CSP 26-028KB (BP012) – ADDENDUM No.02
Field House and Athletics Renovations

ADDENDUM NO. 2

FOR: BP012 FIELD HOUSE & ATHLETIC RENOVATIONS AT 10 HS'S
FOR
FORT BEND ISD
16431 Lexington Blvd
Sugar Land, TX 77479

ADDENDUM DATE: January 20, 2026

100% CD
A3.00-K
ENLARGED RESTROOM PLANS
KEMPNER HIGH SCHOOL

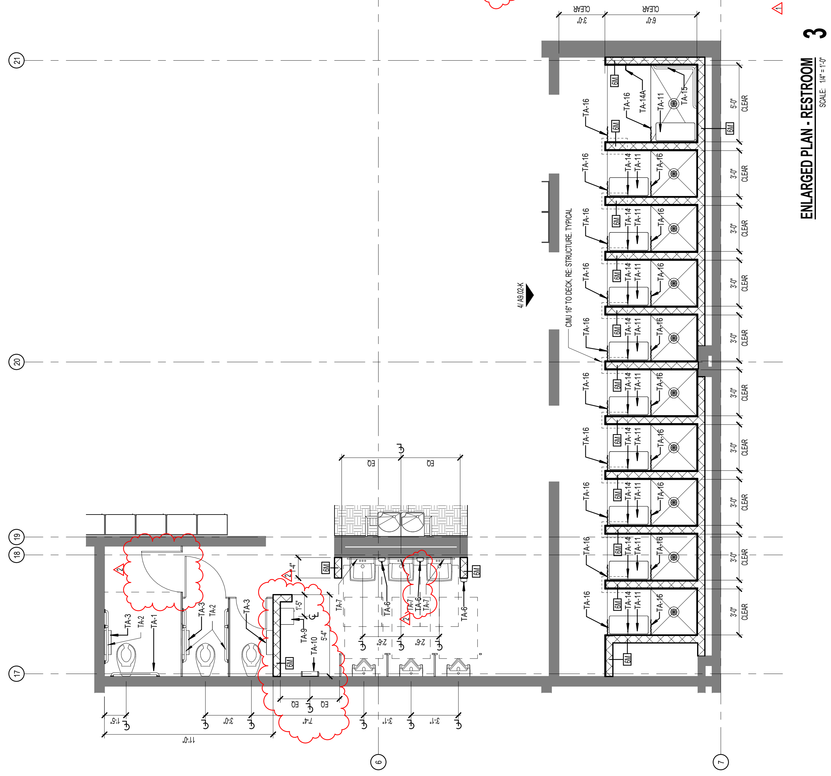
D2-43	A2.02-K		Concrete pavement around the pressbox updated
D2-44	A3.00-K		Addition of paper towel dispenser and wing wall, and relocation of hand dryers. Toilet stall door swing revision. Added soap dispenser.
D2-45	A9.01-K		Revisions to plan to match revisions from 1/A2.01-K.
D2-46	G0.03-M		Revised egress path for detail 1/G0.03-M on concessions building code sheet.
D2-47	AD.03-M		Revised demo scope at Showers H145 to K163 to remove existing cmu plumbing wall.

A2.01-M

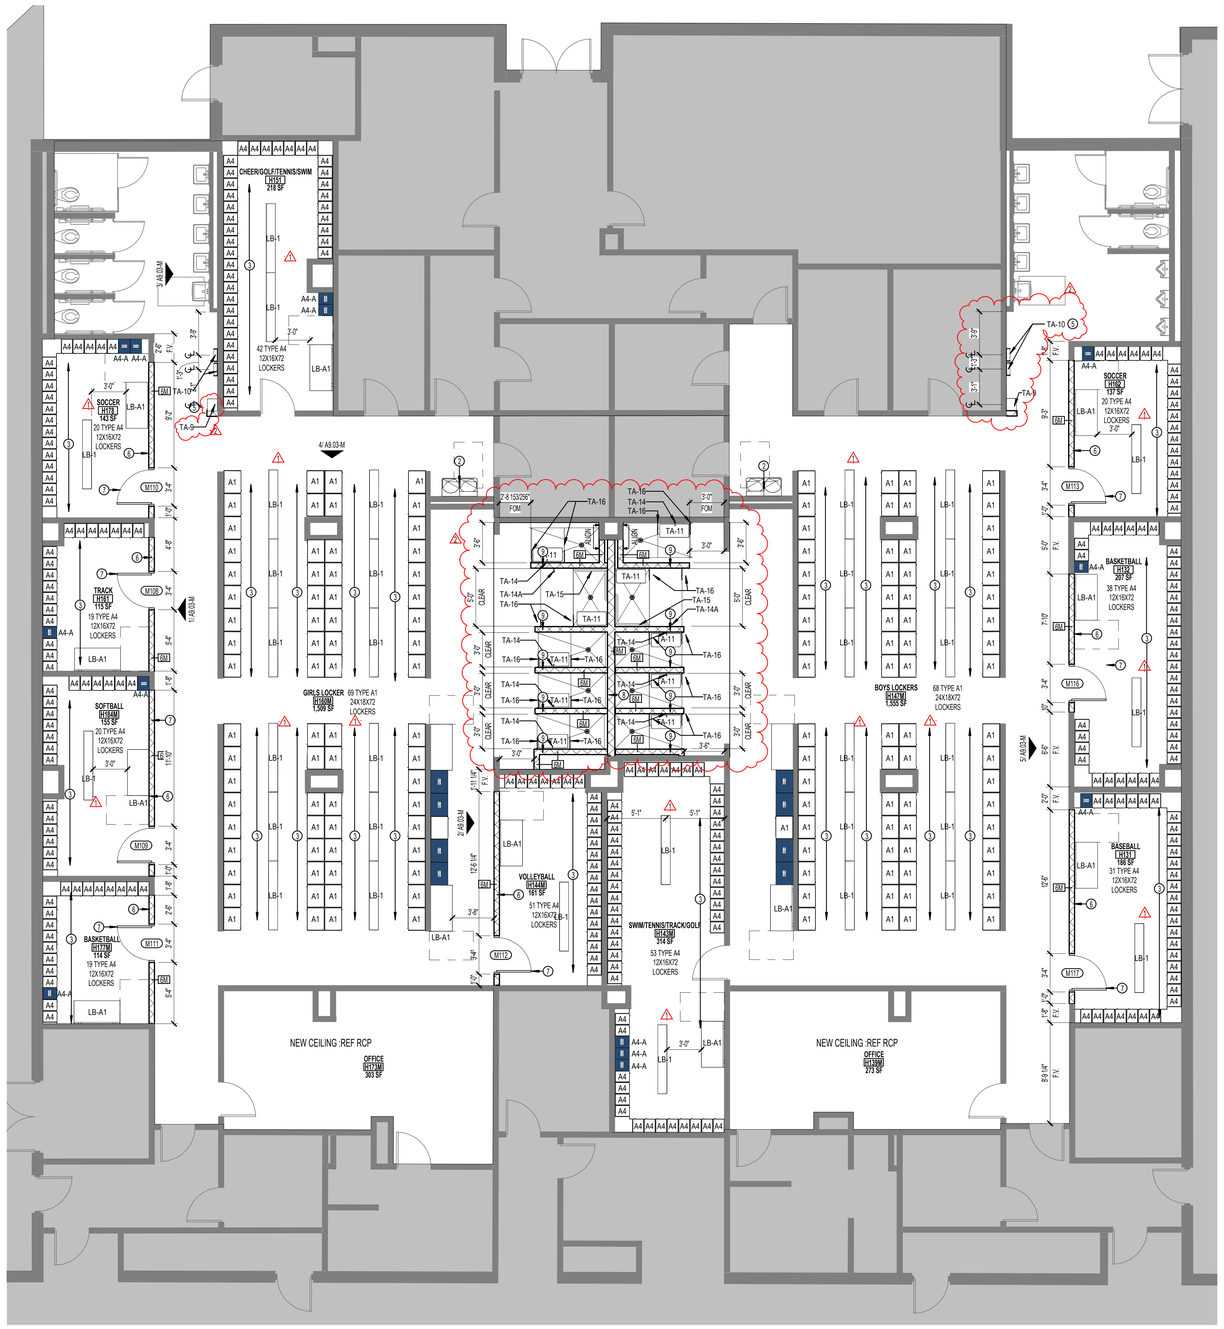
D2-48	A2.00-M		Addition of paper towel dispenser and wing wall. Revision to dimensions and relocation of accessories.
D2-49	A2.01-M		Revision to shower wall clearances.
D2-50	A2.02-M		Addition of paper towel dispenser and wing wall, and relocation of hand dryers. Revision to wall clearances and updated Shower layout
D2-51	A9.00-M		Addition of paper towel dispenser and wing wall
D2-52	A9.01-M		Relocation of material finish legend for legibility.
D2-53	A9.02-M		Revisions to plan to match revisions from 1/A2.02-M.
D2-54	A9.03-M		Addition of paper towel dispenser and wing wall,
D2-55	A1.01-R		Key note updated to show scope of New flooring, wall paint and ceiling paint
D2-56	A2.00-R		Key note updated, Added Locker Curb detail
D2-57	A2.01-R		Mod Bit detail added, Concrete pavement updated. Removed photos of tennis court
D2-58	A2.02-R		Rubber base color updated in the Material schedule
D2-59	A1.01-T		Updated the concrete pavement around PEMB storage

2 T100-E EXISTING GAME CAMERA EQUIPMENT - ELKINS SOFTBALL FIELD
N.T.S.

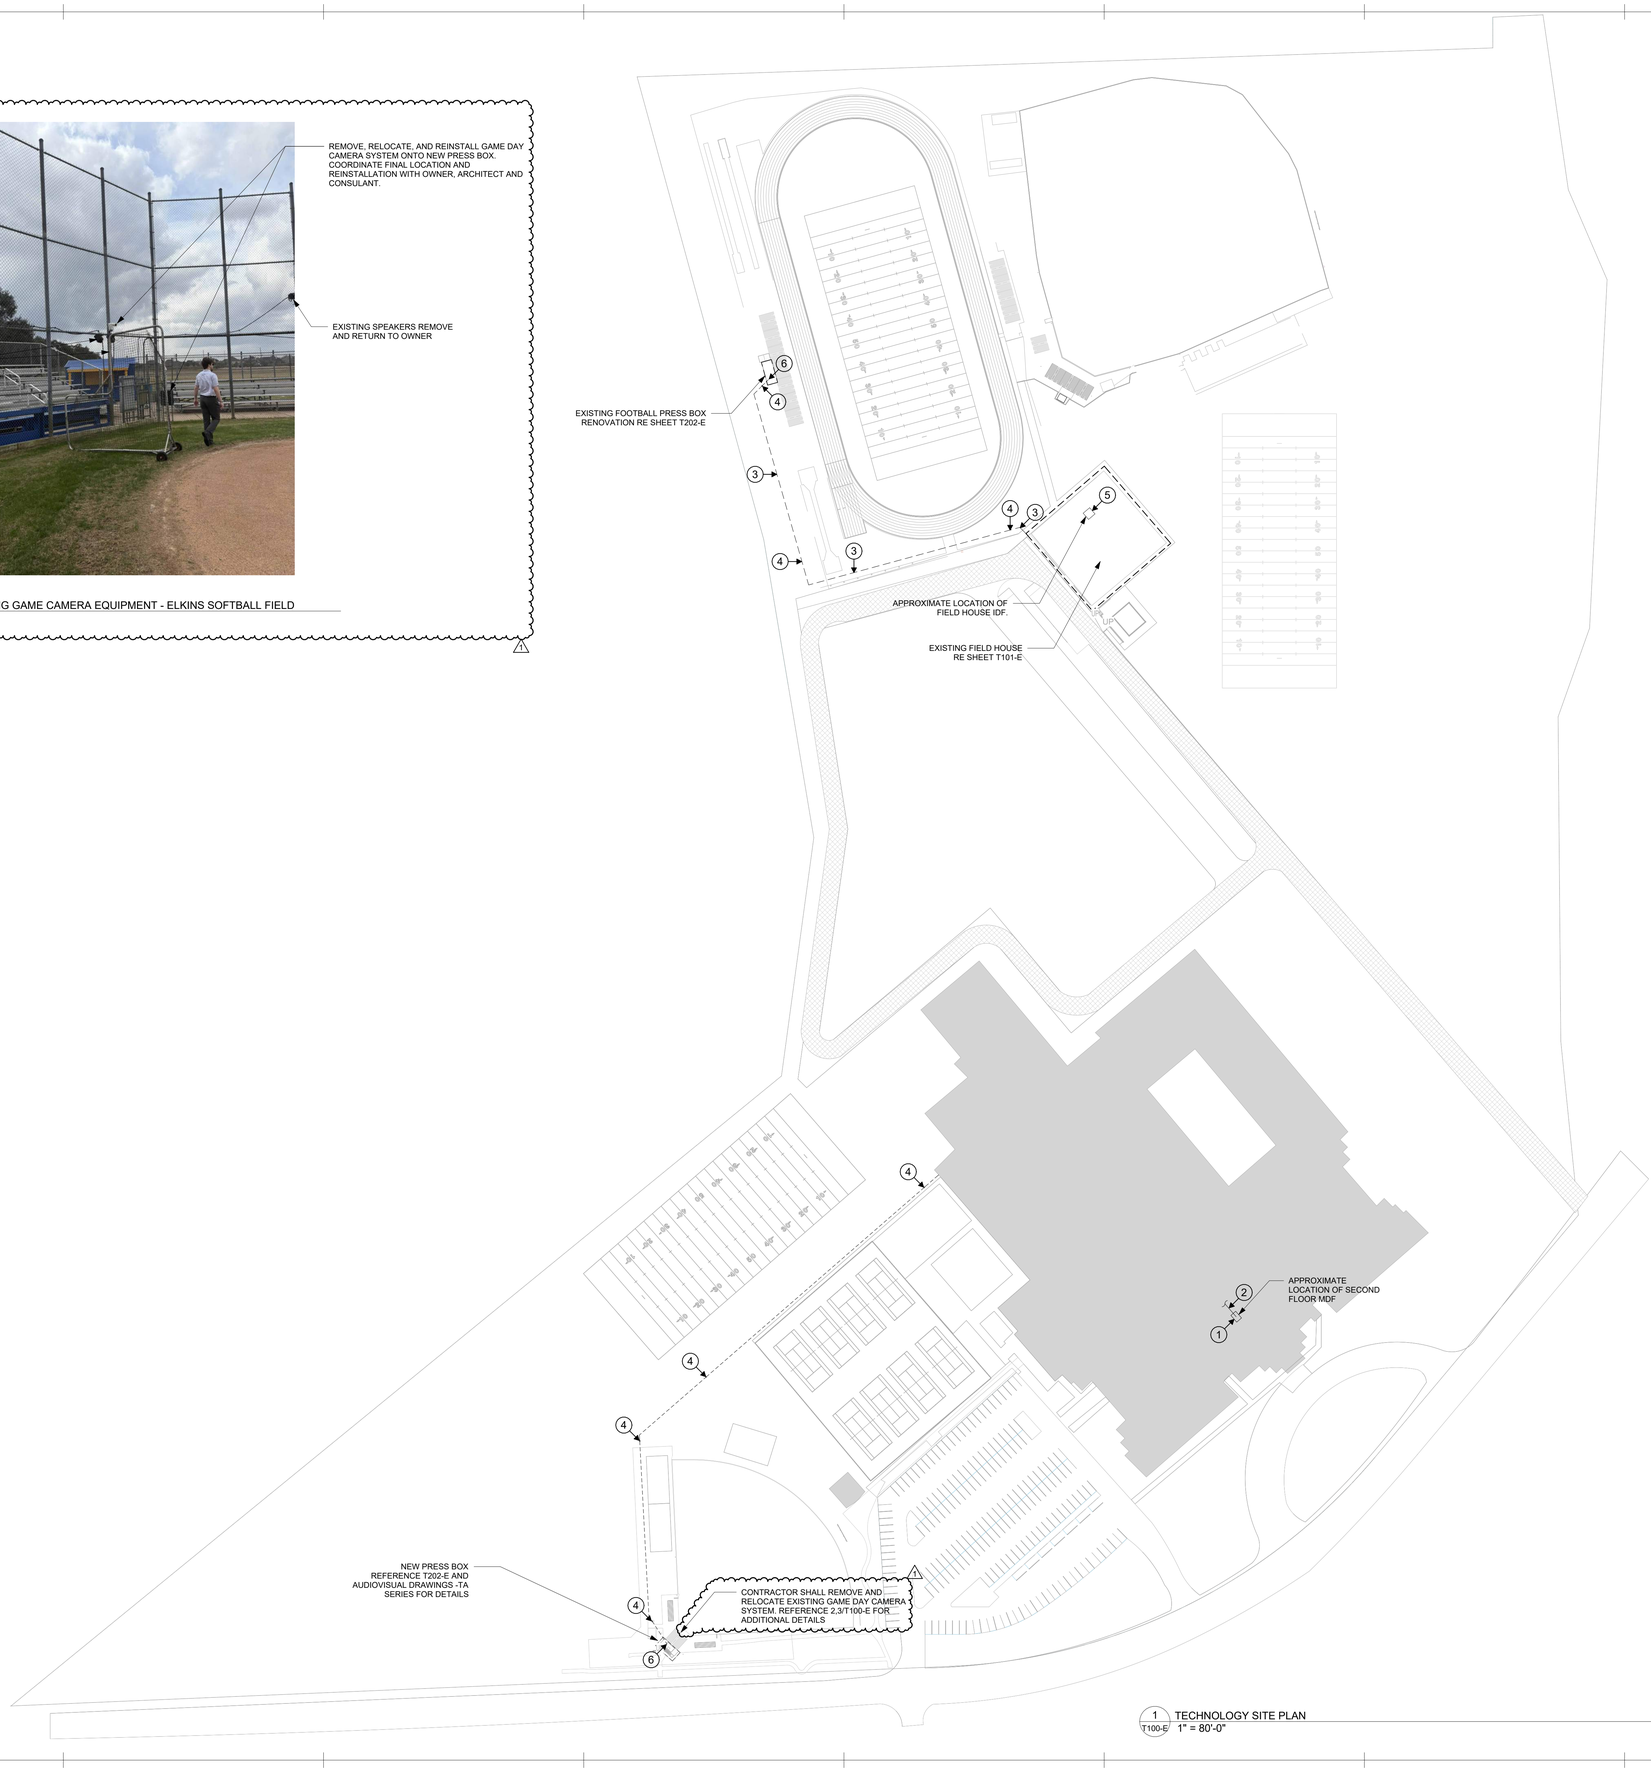
D2-75	T100-E		TECHNOLOGY SITE PLAN, ADDED GAME DAY CAMERA NOTE.
D2-76	T202-E		TECHNOLOGY SOFTBALL PRESSBOX AND HITTING CAGES - ADDED KEYED NOTES.ADDED NEW RECEPTICLE LOCATIONS TO 1&2/T202-E
D2-77	T203-K		TECHNOLOGY LEVEL 1 FLOOR PLAN - SOFTBALL PRESSBOX, ADDED KEY NOTES 2, 3, 4 AND DETAIL 1/T203-K
D2-78	TD102-M		ADDED SHEET TD102-M, TECHNOLOGY DEMOLITION FLOOR PLAN FIELD HOUSE
D2-79	T203-M		ADDED SHEET T203-M, TECHNOLOGY DEMOLITION FLOOR PLAN FIELD HOUSE
D2-80	T201-W		TECHNOLOGY SOFTBALL PRESSBOX AND HITTING CAGES - ADDED KEYED NOTES 1,2,3. ADDED NEW RECEPTICLE LOCATIONS TO 2,3 &4/T201-W.
